Fame Design Ltd. (New)

Lalpur, Fatullah, Narayangonj.
(23.633857, 90.478877)

10th December 2020

1. Production Building (Building 1) (single storied)
2. Utility Building (Building 2) (G+1)

Connection gap between rafter joints

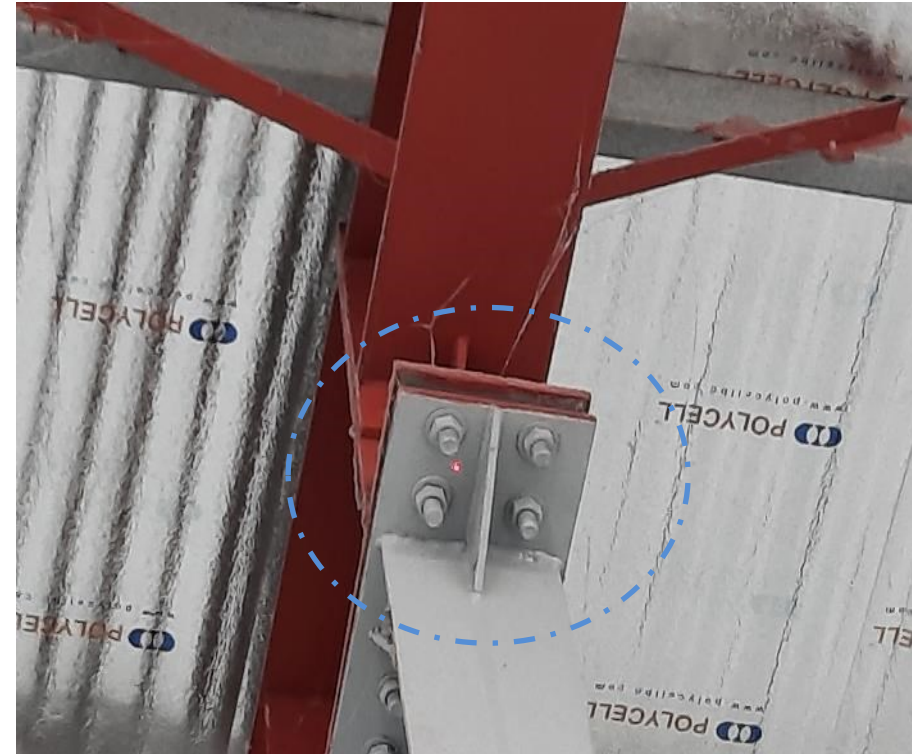
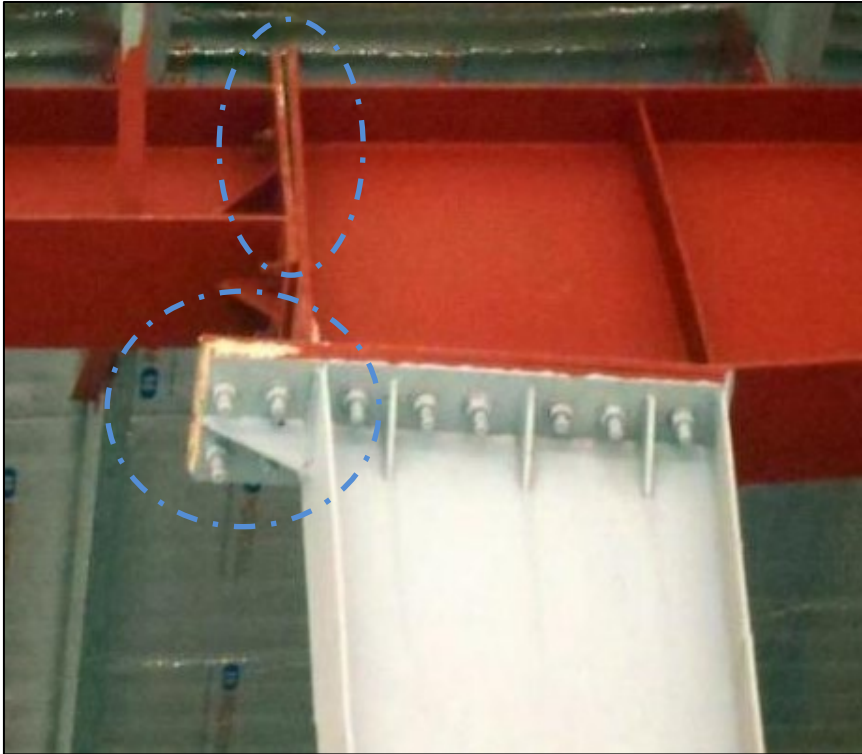
Connection gap was found between connecting plates of the rafters and columns. Building engineer is required to seal the gaps between connecting plates with proper repair methodology.

Footings are stressed above normal design limit.

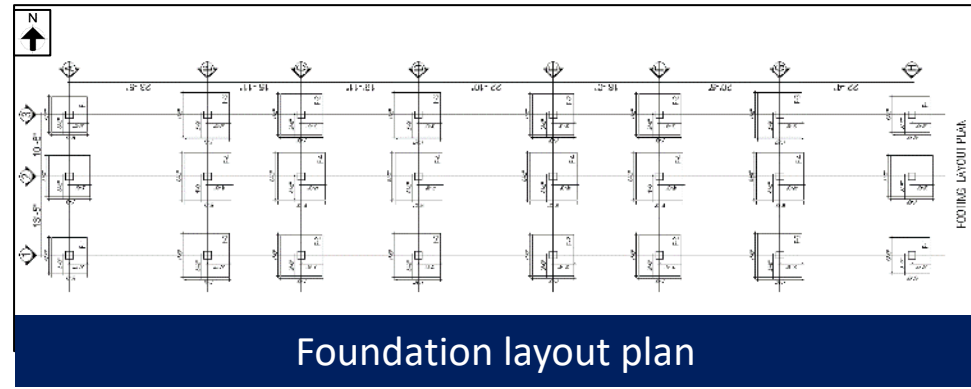
As per recommendation of geotechnical investigation report, the allowable bearing capacity is 0.65 tsf (7.1 ton/m^2) considering F.S 2.5.

Cursory calculation indicates that footing appears to be stressed above normal design limits considering the recommended soil bearing capacity in geotechnical report and footing sizes in drawing. Factory engineer is required to review the adequacy of footings and comply with BNBC.

Exposed rebar at rooftop prone to corroded

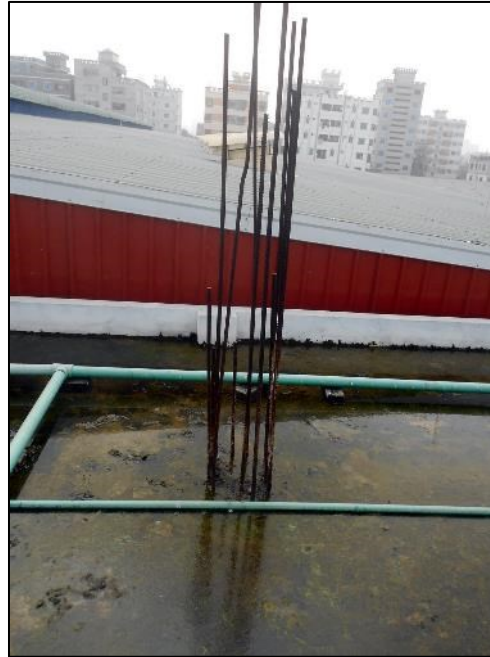
Exposed reinforcement at roof level

Exposed reinforcement found left at roof level. Building engineer is required to remove the exposed rebar otherwise provide rust proof paint to protect from corrosion.
